Proposal for the 03 Series of Amendments to UN Regulation No. 137 (Frontal impact with focus on restraint systems)

Submitted by the expert from OICA

The text reproduced below was prepared by the expert from the International Organization of Motor Vehicle Manufacturers (OICA). It replaces ECE/TRANS/WP.29/GRSP/2023/20 to resolve editorial issues. The proposal aims to introduce requirements for the post-crash safety of hydrogen-fuelled vehicles based on the Amendment 1 to UN GTR No. 13 (Hydrogen and Fuel Cells Vehicles). The modifications to the current text of the UN Regulation are marked in bold for new characters and the modifications from ECE/TRANS/WP.29/GRSP/2023/20 are given in red fonts.

Model A

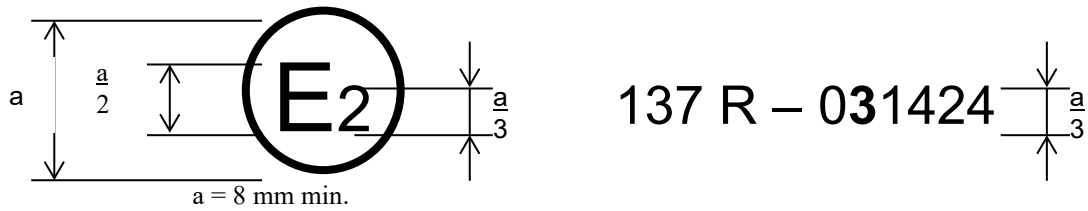
Annex 2, amend to read:

The above approval mark affixed to a vehicle shows that the vehicle type concerned has, with regard to the protection of the occupants in the event of a frontal collision, been approved in France (E 2) pursuant to Regulation No. 137 under approval number 011424. The approval number indicates that the approval was granted in accordance with the requirements of Regulation No. 137 03 series of amendments.

Model B

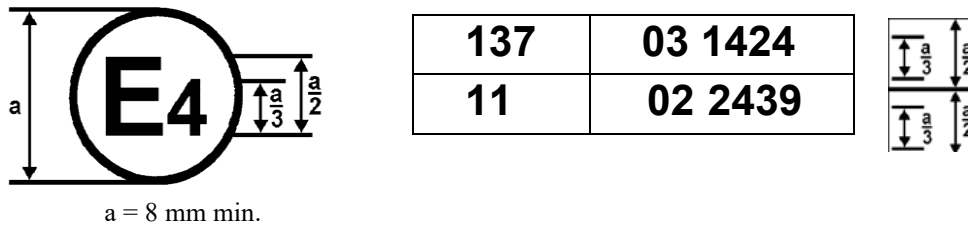
The above approval mark affixed to a vehicle shows that the vehicle type concerned has been approved in the Netherlands (E 4) pursuant to Regulations Nos. 137 and 11.¹ The first two digits of the approval numbers indicate that, at the dates when the respective approvals were granted, Regulation No. 137 incorporated the 03 series of amendments and Regulation No. 11 incorporated the 02 series of amendments.
